CITY OF SAN MARINO

DESIGN REVIEW COMMITTEE AGENDA

WEDNESDAY, OCTOBER 17, 2018

City of San Marino AGENDA REPORT

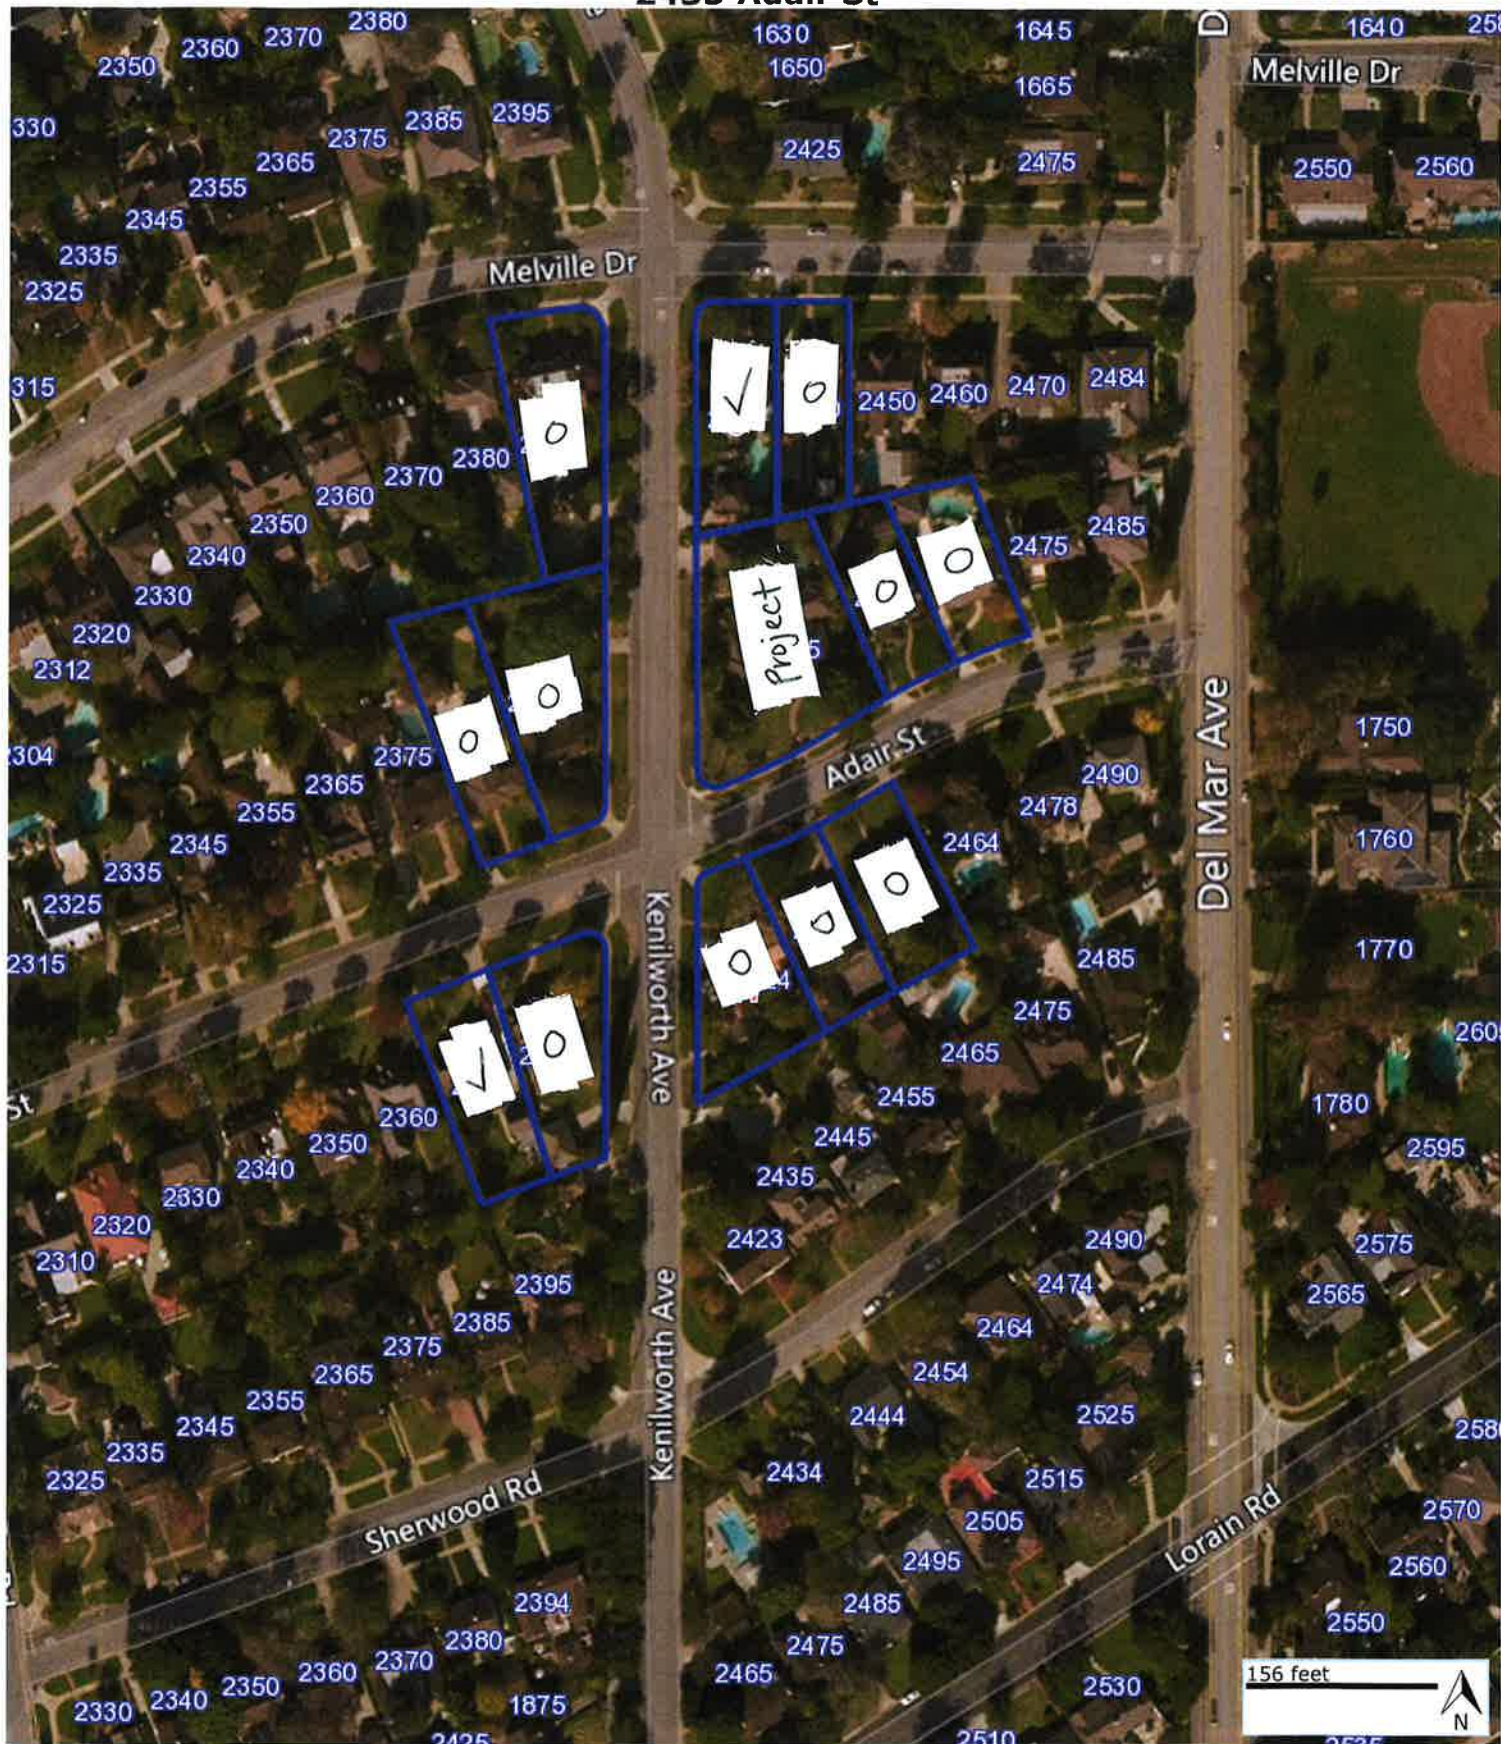
Comments: For the purpose of analyzing compatibility with existing residences, staff observed the house adjacent to the subject property, located along the same side of Kenilworth Avenue, in between Adair Street and Melville Drive (2424 Melville Drive). The adjacent neighbor's house is also improved with a street-facing block wall that is consistent in size, location, and appearance as the proposed block wall on the subject property.
